06-ESQ-099

REVISIONS TO THE REQUIRED SUBMITTAL FOR THE DEMONSTRATION BULK
VITRIFICATION SYSTEM (DBVS) FACILITY OFF-GAS TREATMENT SYSTEM DESIGN

REVISED FIGURES F-145579-36-A-0100, -0102, AND -0105 OF RPP-24544,
"DEMONSTRATION BULK VITRIFICATION SYSTEM IQRPE/RCRA DESIGN REVIEW
PACKAGE FOR THE MAIN OFF-GAS TREATMENT SYSTEM" VOLUMES 1 - 5
(RPP-24544, REV. 1D, DATED APRIL 26, 2006)

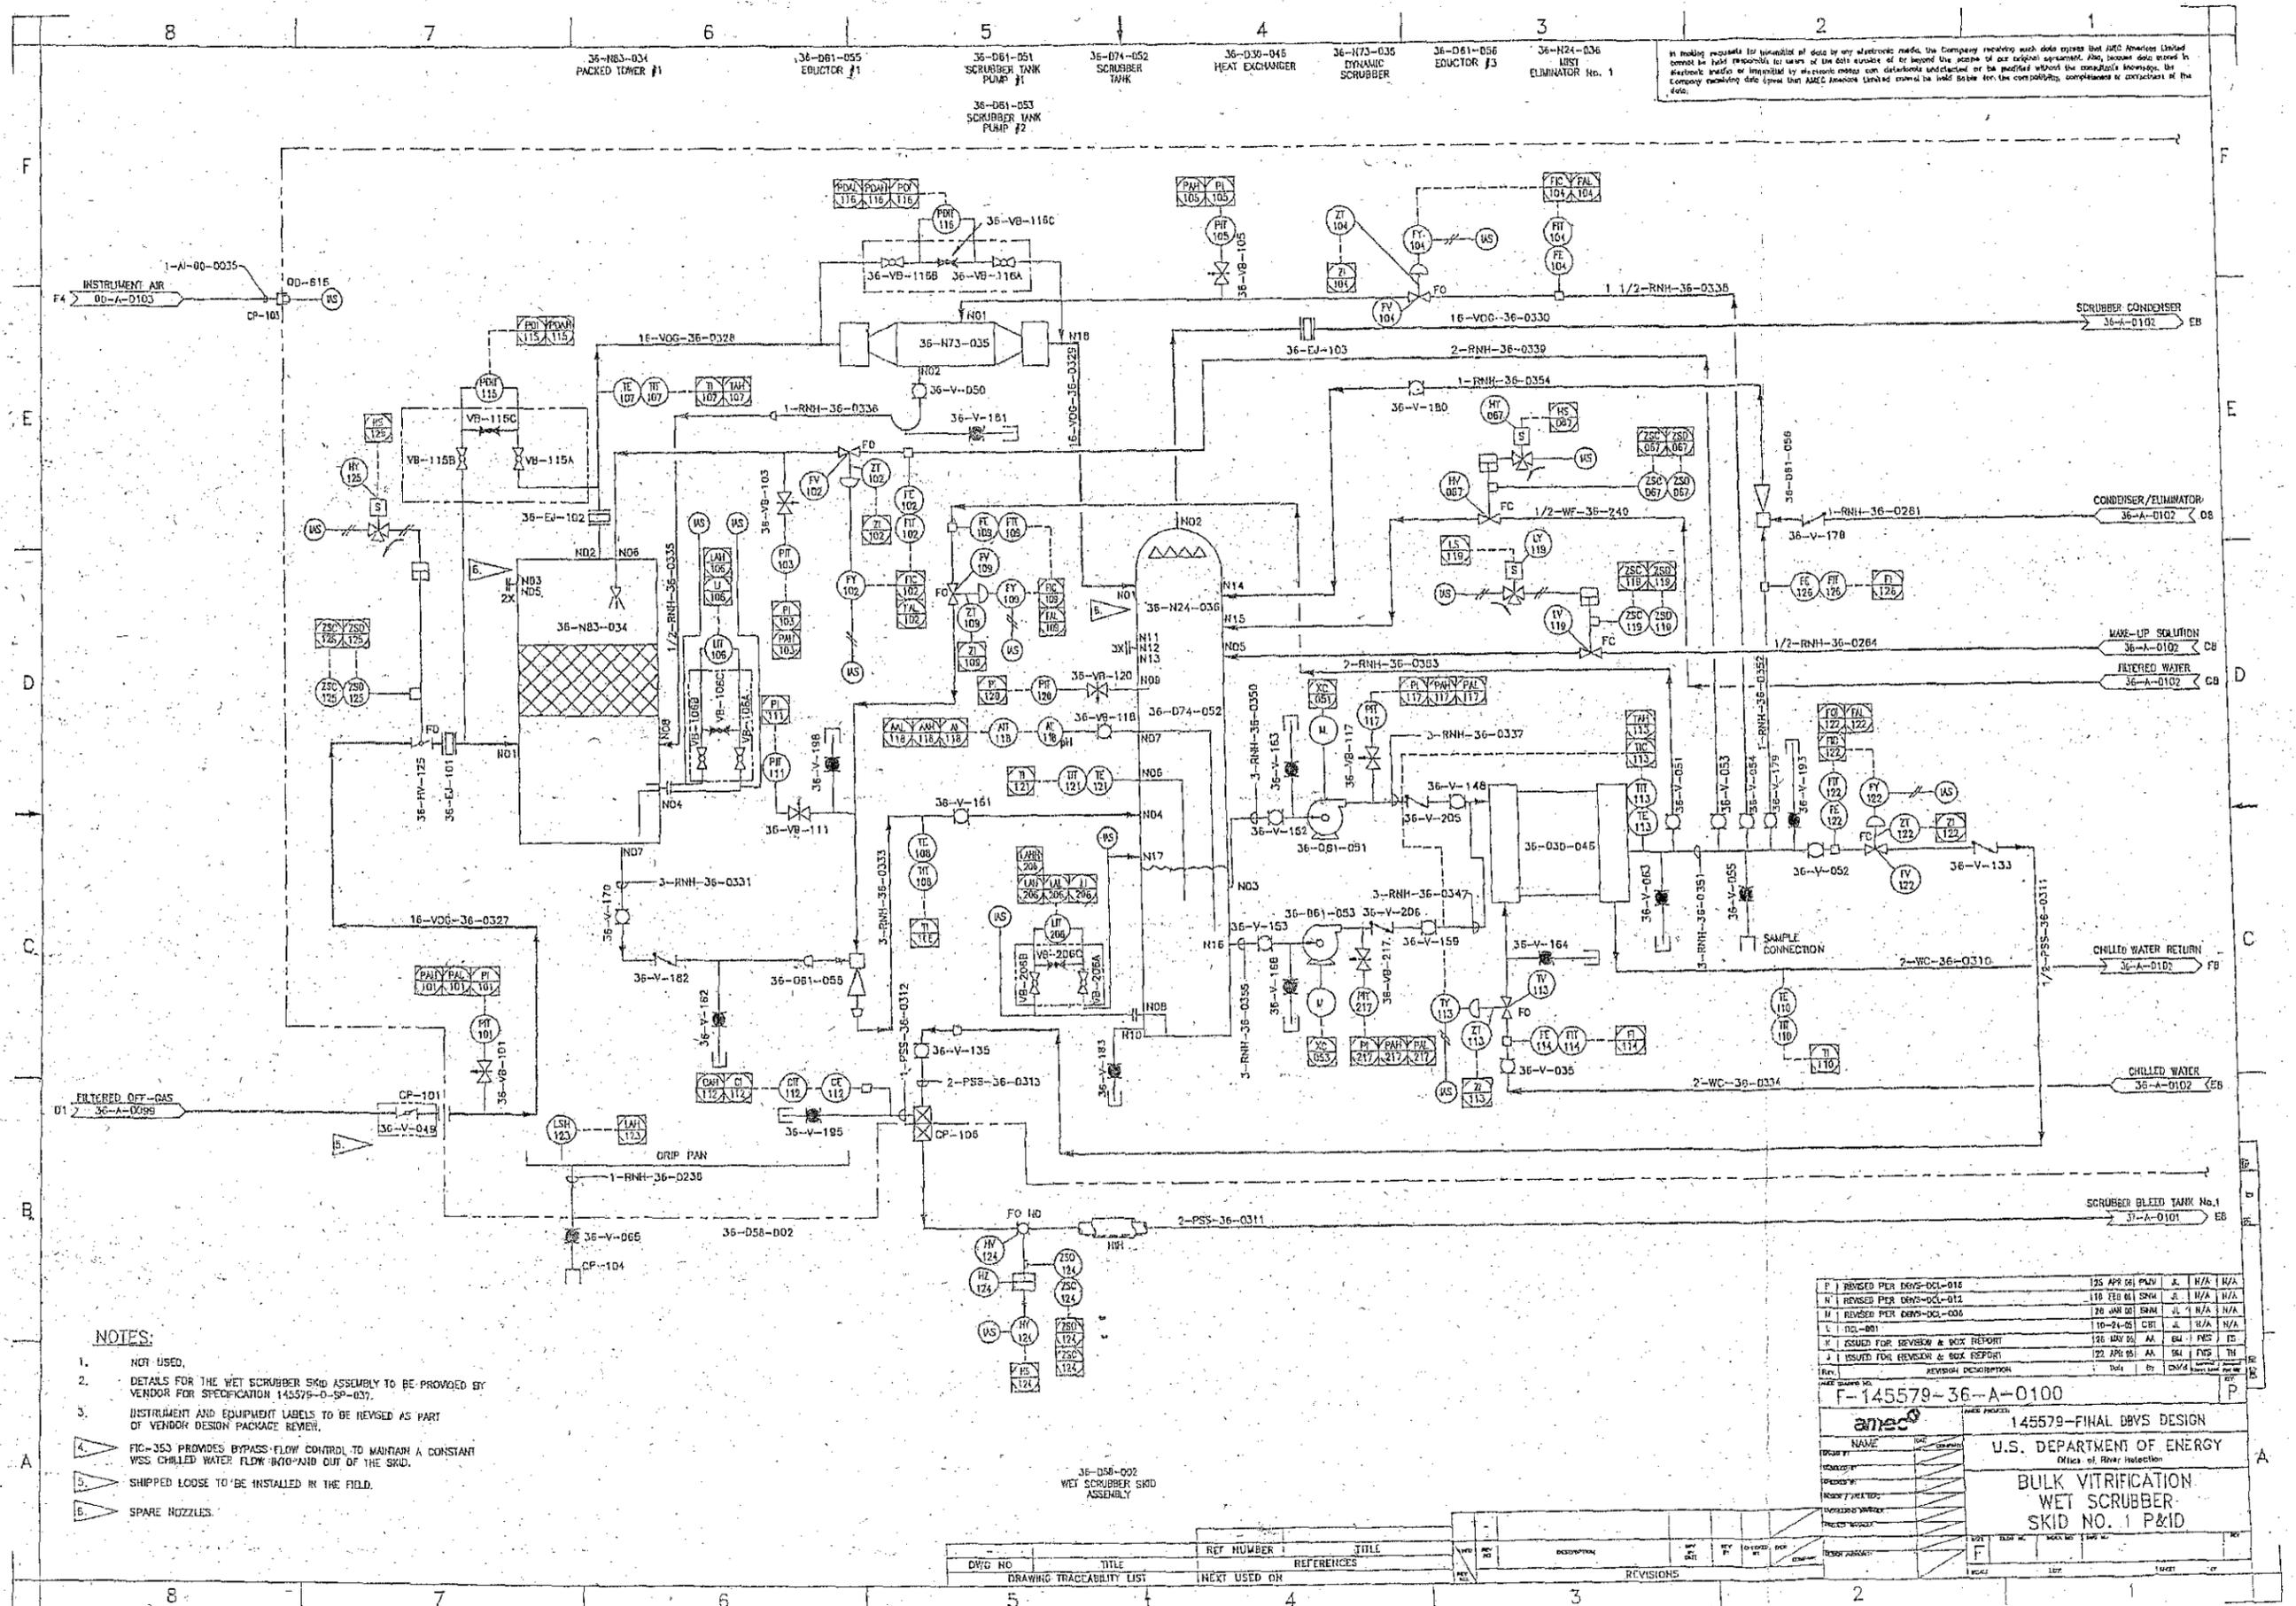
F	REVISED PER DBVS-DCI-016	125	APP	SH	PLN	J	N/A	N/A
N	REVISED PER DBVS-DCI-012	118	TEG	SH	SNW	J	N/A	N/A
M	REVISED PER DBVS-DCI-006	110	AW	SH	SNW	J	N/A	N/A
L	DCI-001	110	AW	SH	SNW	J	N/A	N/A
V	ISSUED FOR REVISION & BOX REPORT	125	APP	SH	PLN	J	N/A	N/A
J	ISSUED FOR REVISION & BOX REPORT	122	APP	SH	PLN	J	N/A	N/A
Rev.	REVISION DESCRIPTION	DATE	BY	CHK'D	DATE	BY	CHK'D	DATE
